**CONTRACT DOCUMENTS & TECHNICAL SPECIFICATIONS
ADDENDUM No. 1**

BELLEVUE STATE PARK

**Gun Club Road (Related Utilities and Amenities)
Contract No. 2013-NVF-100
December 16, 2013**

NVT RETAIN PARCEL
TEST BORING LOCATIONS

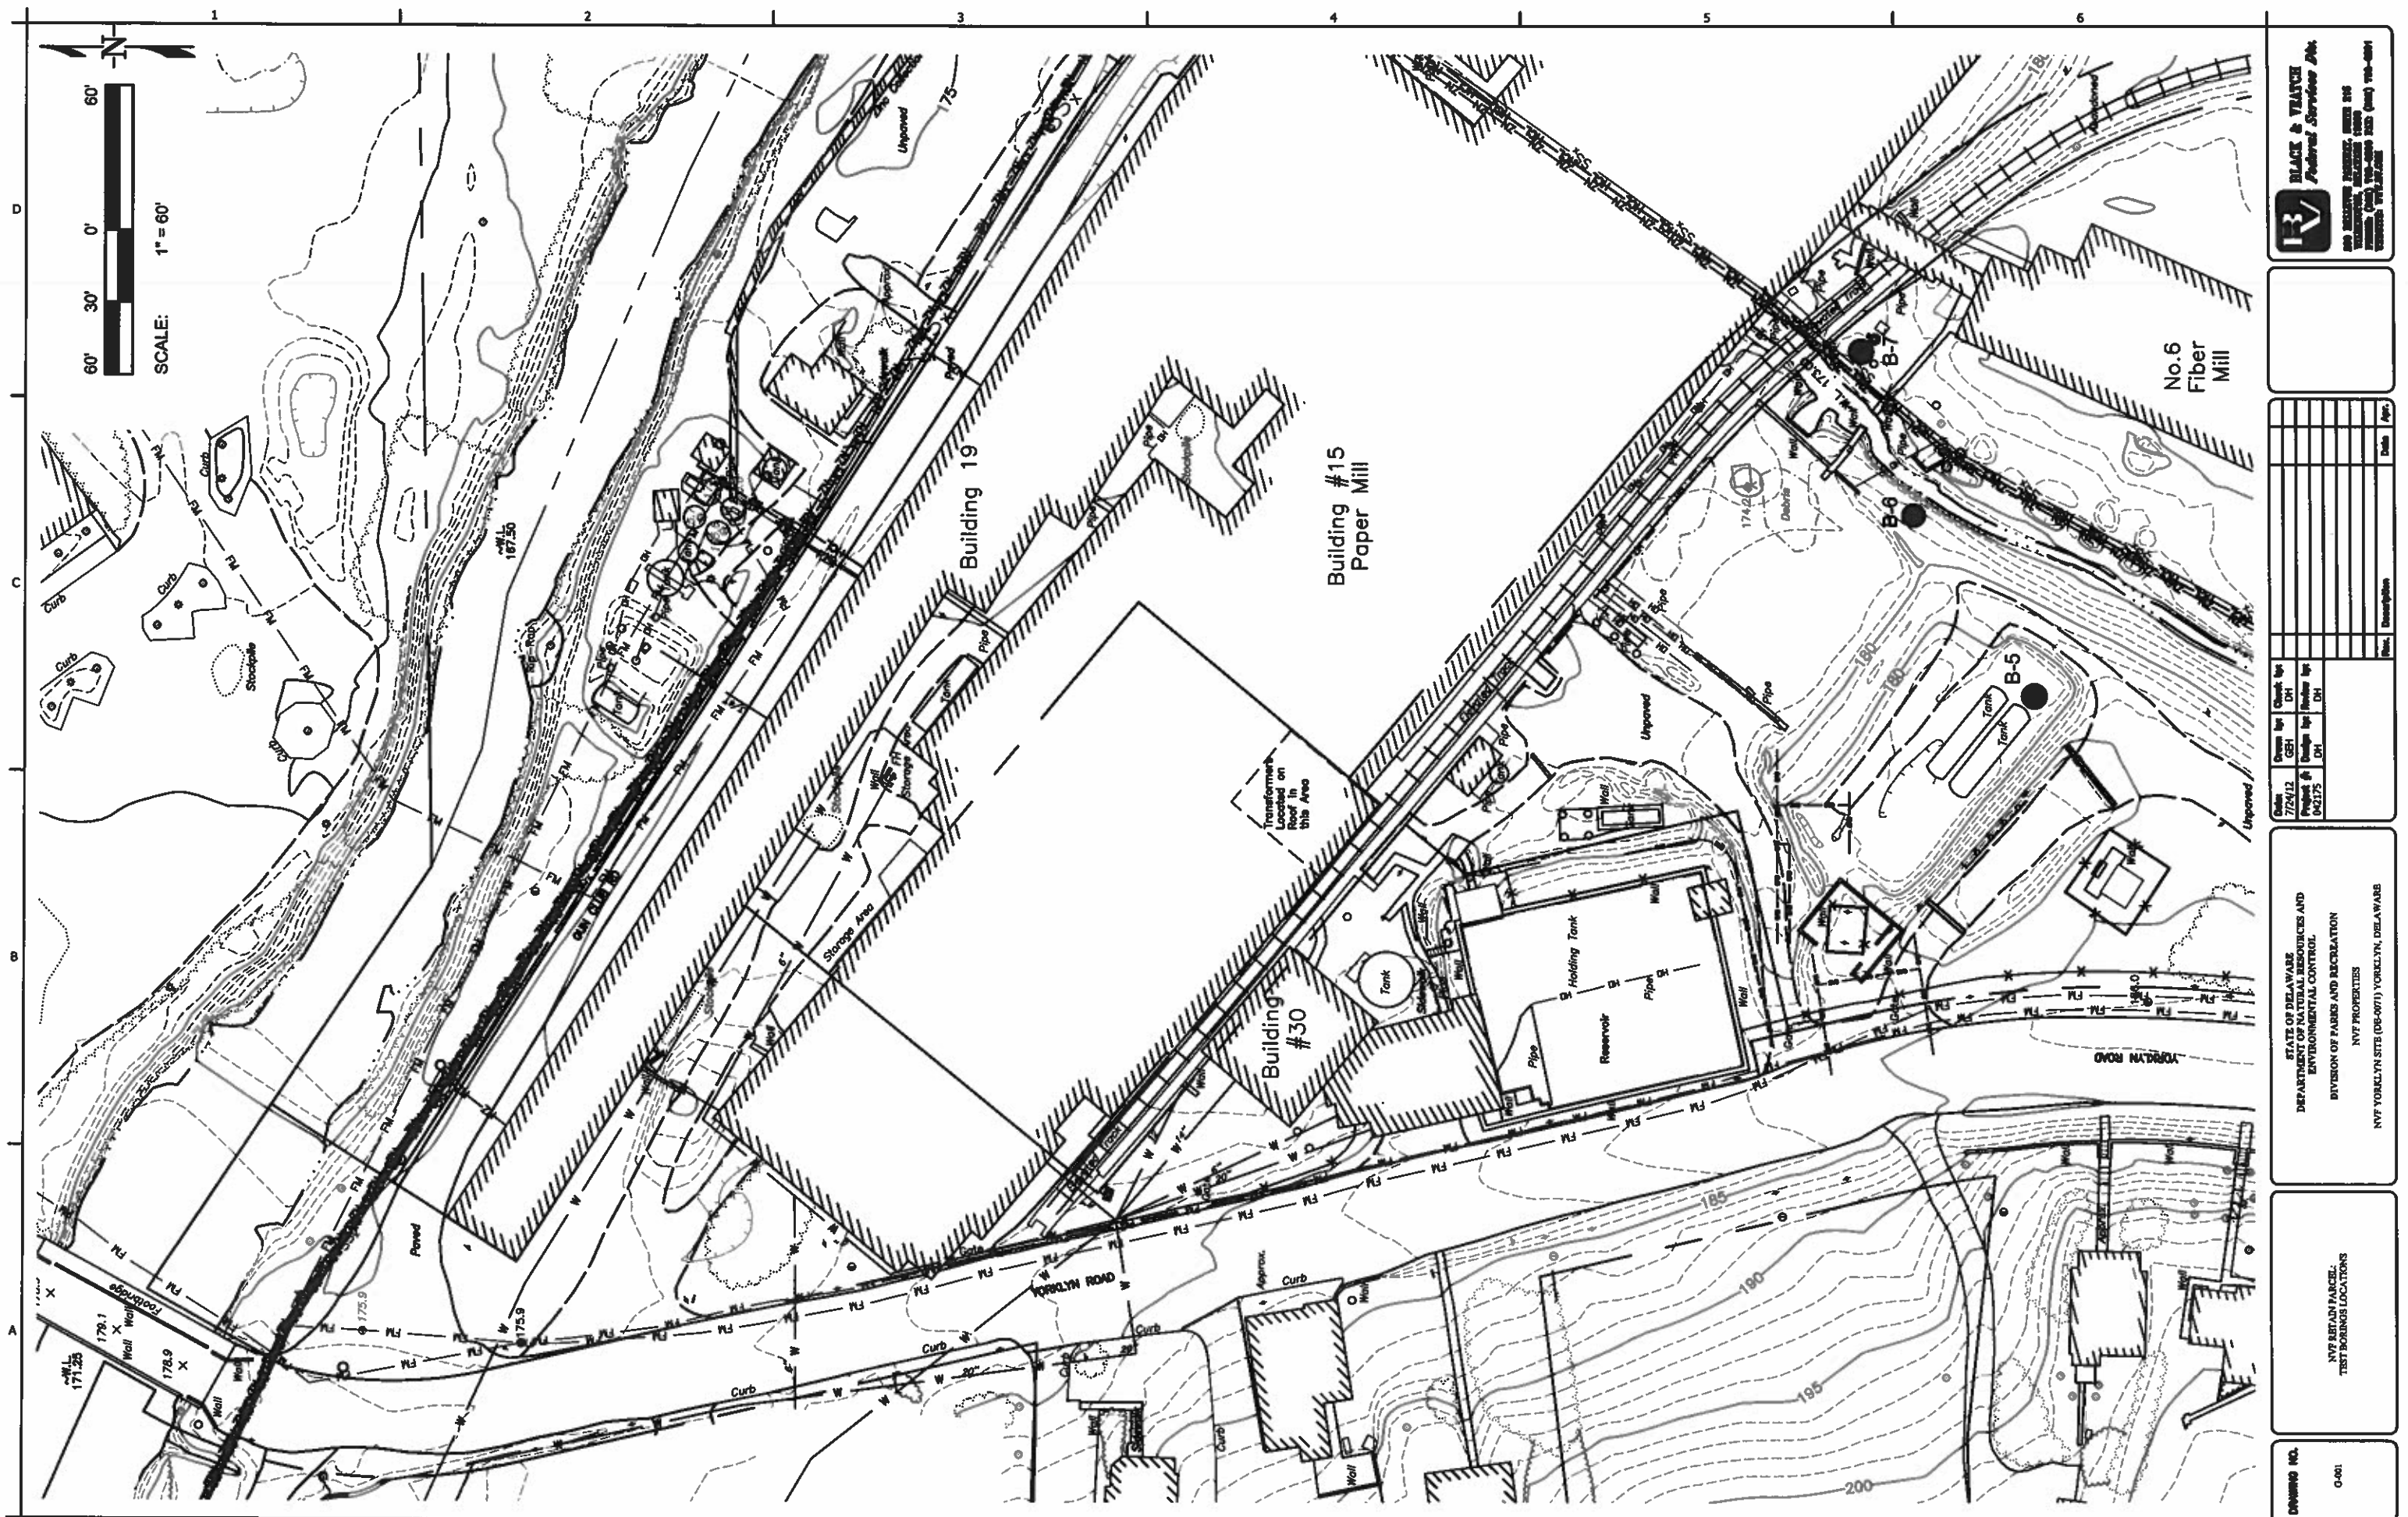
- 1.) Is there a provision for rock excavation (ie unit price)? If not are there boring logs which we can review to make our own determinations?
Answer: There are no provisions for rock excavation. Boring logs have been included with this addendum.
